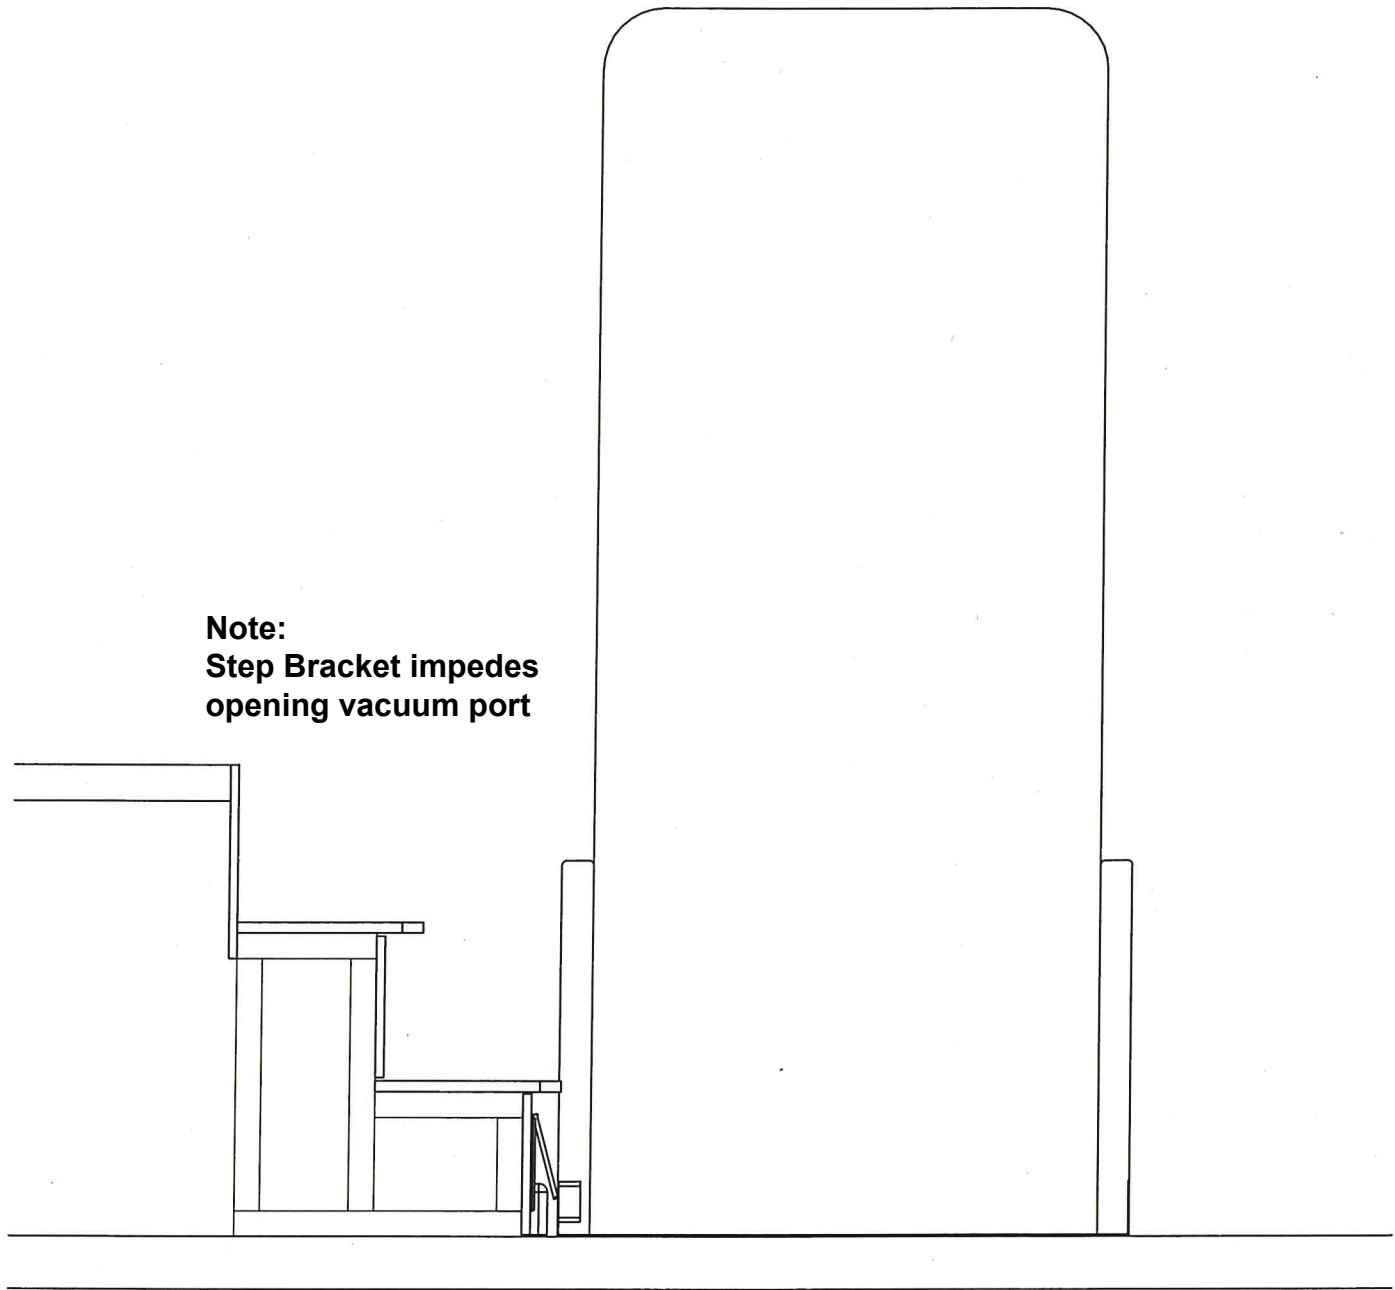
Note:
Vacuum Ports were installed too close to MorRyde Step Bracket and won't open.

**Note:
Step Bracket impedes opening vacuum port**

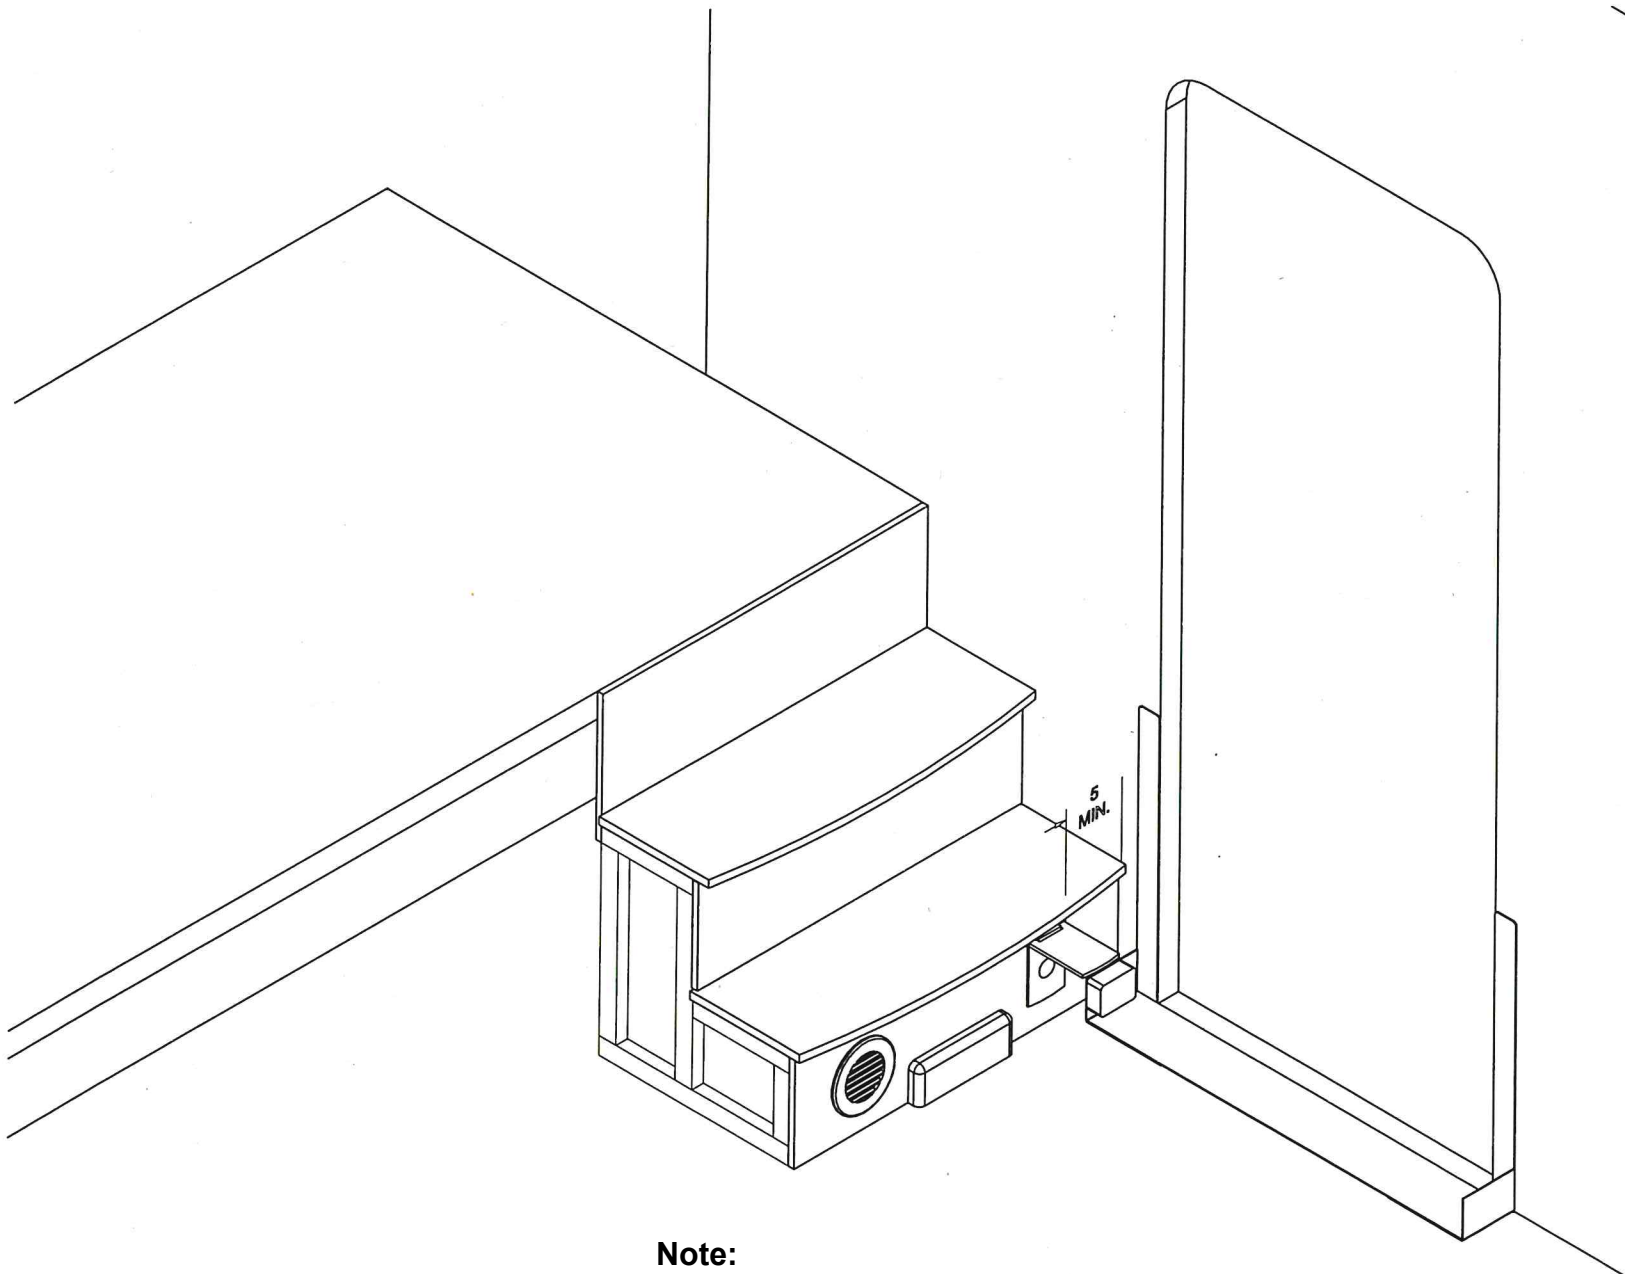
**Note:
Step Bracket impedes
opening vacuum port**

Note:
Vacuum Port Need to move at least
1" inboard, away from sidewall.

Note:
Moving 1" will allow it to open.

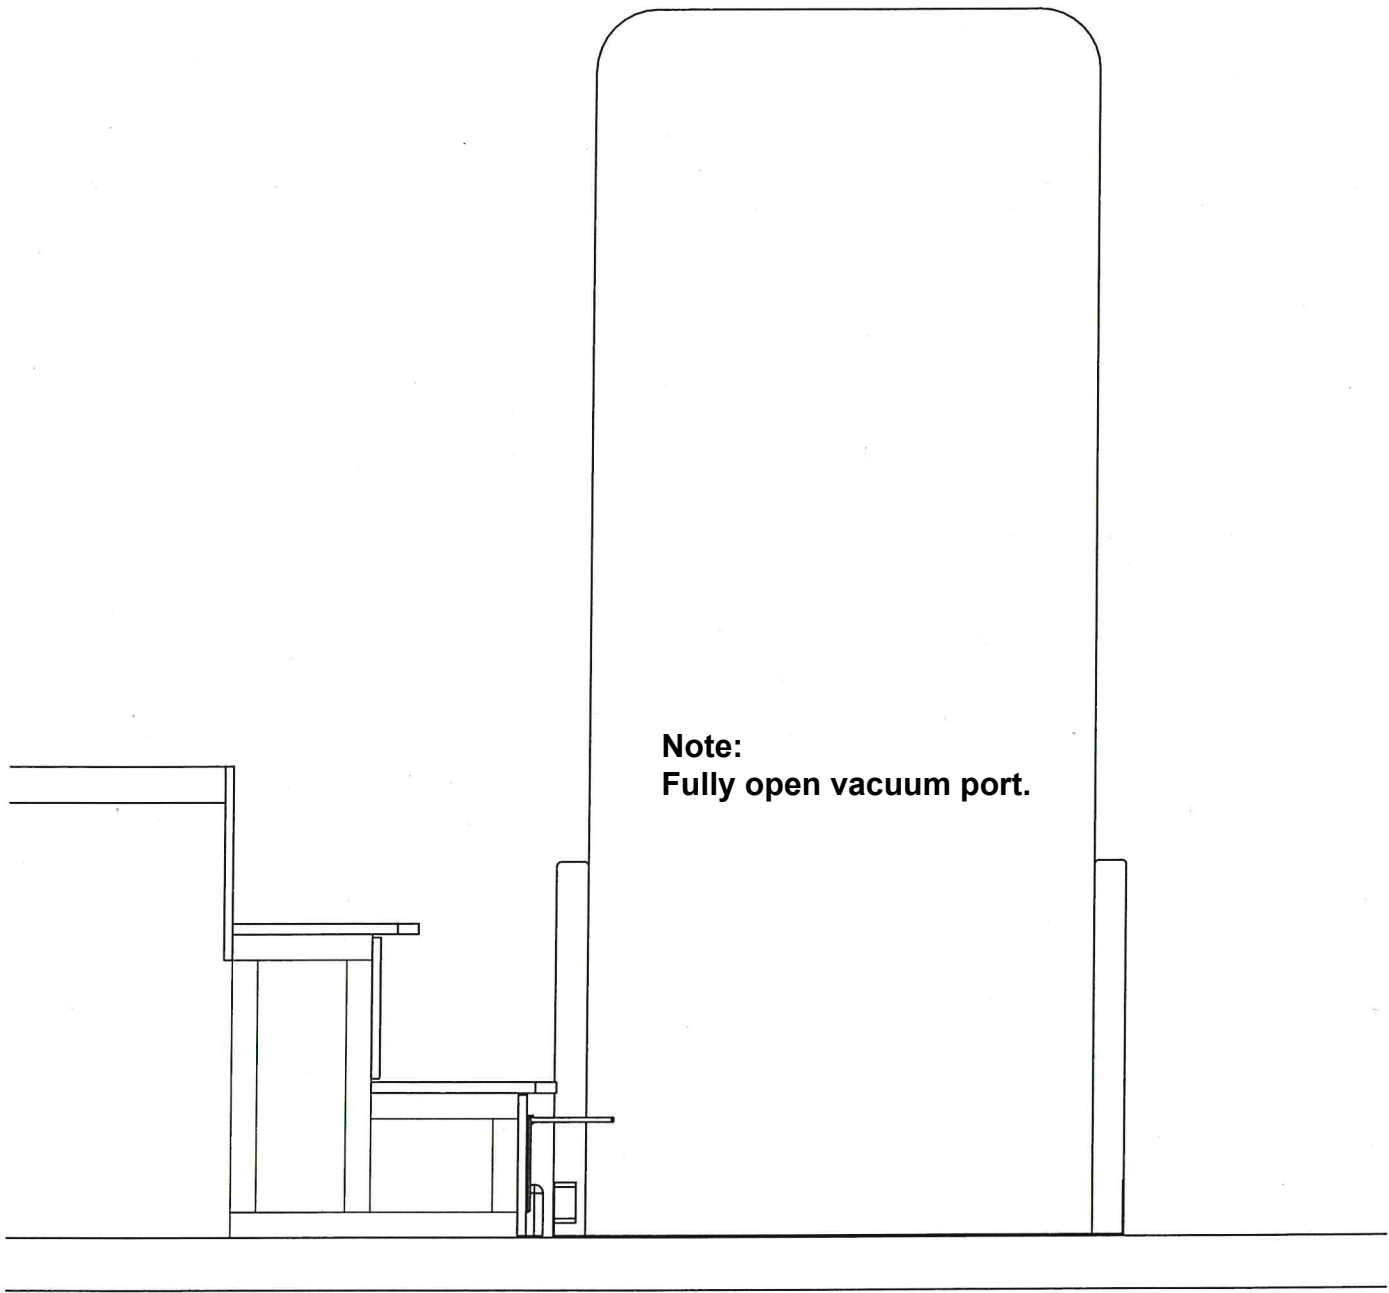
**Note:
Fully open vacuum port.**
